Re: **Submission of PG&E's 2026-2028 Wildfire Mitigation Plan Revision Notice
Response Non-Substantive Errata R1**

Errata to Pacific Gas and Electric Company's 2026-2028 Wildfire Mitigation Plan Revision Notice Response

Figure PG&E-8.3.8.2-1: Inspection Selection Process
(in the 2026-2028 Base WMP)

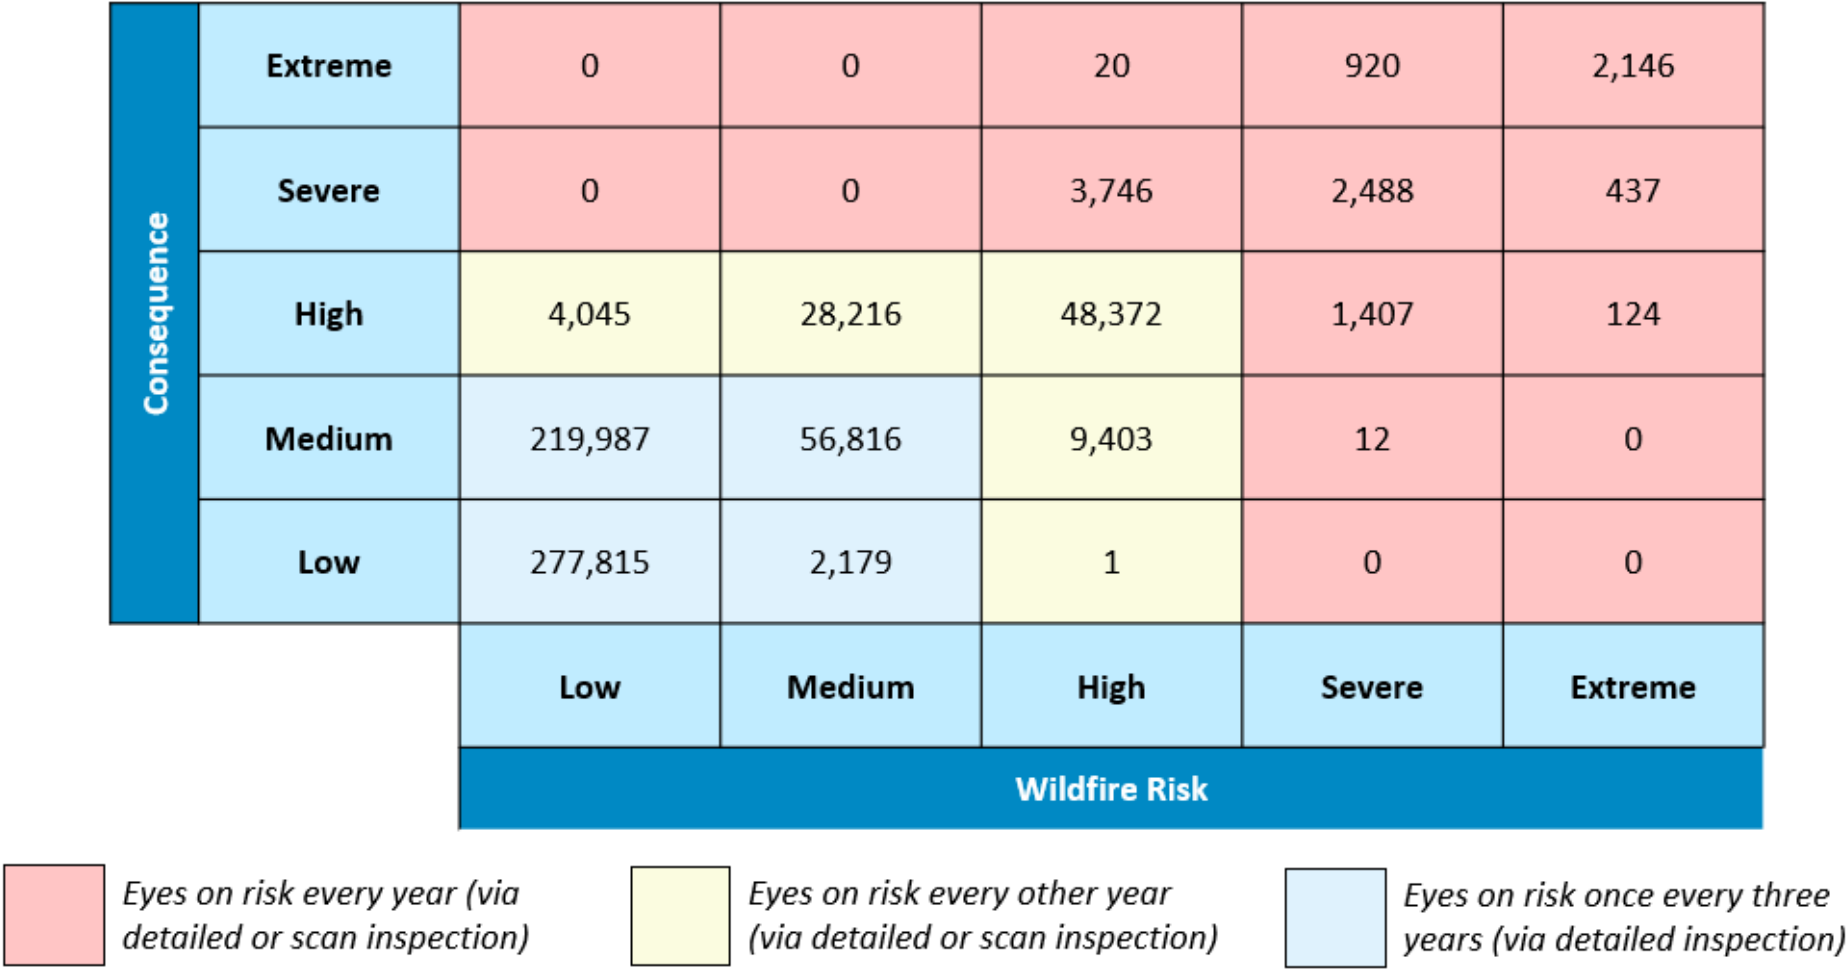
Issue/Reason for Correction	Location of Issue in the	Adjustment(s) Made
11	Table update to correct typographical error for GH-14	2026-2028 Base WMP R1 Vol.1: Table 8-1: Grid Design, Operation, And Maintenance Targets By Year, P. 179	Replaced Table 8-1 with updated % Planned in HFTD for 2026 for GH-14. n/a 100% 100% See Attachment 5 below
12	Table update to remove unnecessary line item	2026-2028 Base WMP R1 Vol 1: Table PG&E-8.2.1-4: Covered Conductor And Undergrounding Impacts On The Likelihood Of Ignition, P. 198	Replaced Table PG&E-8.2.1-4 with removal of Risk Driver: Wire-to-wire Contact. See Attachment 6 below
13	Table update to remove unnecessary line item	2026-2028 Base WMP R1 Vol.1: Table PG&E 8.3-1: Asset Inspection Frequency, Method, And Criteria, P. 231	Replaced Table PG&E 8.3-1 with removal of Inspection Activity: Aerial Pilot. See Attachment 7 below
14	Figure update to use more precise language	2026-2028 Base WMP R1 Vol.1: Figure PG&E-8.3.8.2-1: Inspection Selection Process, P. 244	Replaced Figure PG&E-8.3.8.2-1 with updated language for clarity. See Attachment 8 below
